Ref: 18983/RC/4996-02/CL

Planning Ref No: SD21A/0051  
Decision Order No: 0545  
Applicant: RGR Holdings Ltd.

**Re: Request for Additional Information**

**Development:** The continuance of use of the existing 3 buildings and all associated external areas for storage and warehousing of motor vehicles, plant, machinery and other durable products for the sale by public auction, all associated ancillary uses including support staff and office facilities and all associated site and development works comprising hard and soft landscaping areas, roads and footpaths, car parking, boundary treatments/fencing, signage and water services infrastructure. The development described above was previously permitted under Reg. Ref. SD18A/0126 and the duration of the permission was limited to two years by condition 9 of that permission. A protected Structure – former Gun Powder Store (RPS Ref. 205) – is located within the application site.

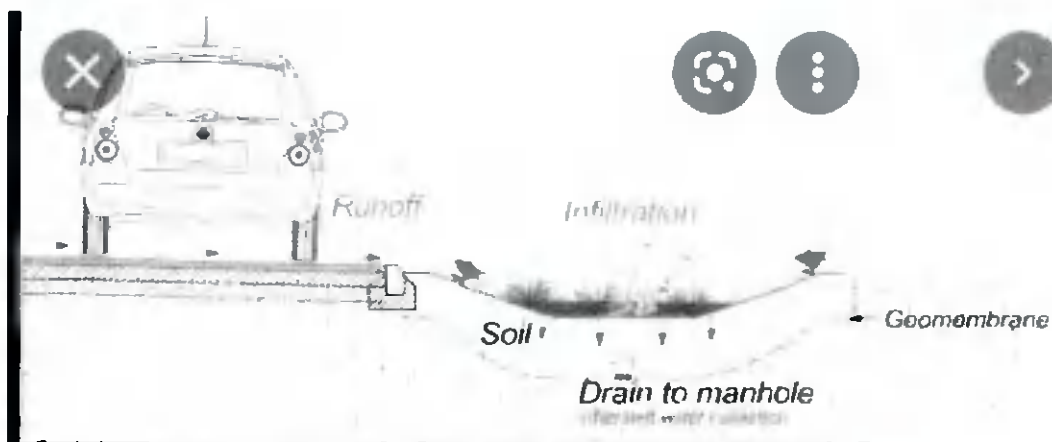
5. *Clarification of Item No. 5: The Applicant is requested to submit further detail in relation to the sustainable drainage proposals. These should be shown on both the landscape plans and the drainage plans and they should be consistent. The swale should be vegetated. The detail of all SuDS features showing how they work and how much water they are attenuating.*

**Area (B):** Rain water harvesting system, Rain garden planting bed and Trees & Storm Water Soil Cell.

Hardstanding & Roof Catchment Area 1.47 Ha. Drainage system. SuDS proposal diverting water from roof and hardstanding areas to a rain water harvesting system for use as grey water which is fed back to the building and to irrigation system with the excess water overflows from the storage tanks to rain garden planting bed where the existing soil is replaced with 'filter soil' (a mix of 20% topsoil, 30% compost and 50% sand). Beds are planted with vegetation that is tolerant of drought and wet conditions as shown in planting Schedule.

*Grey water In Building:*

Item	Quantity	M <sup>3</sup> /day
<b>Proposed Development</b>		
Toilet: 76 persons	50 L/hd/Day	3.8
Outdoor usage :	1,800 L/Day	1.8
Miscellaneous :	900 L/Day	0.9
<b>Total Demand</b>		<b>6.5 m<sup>3</sup></b>
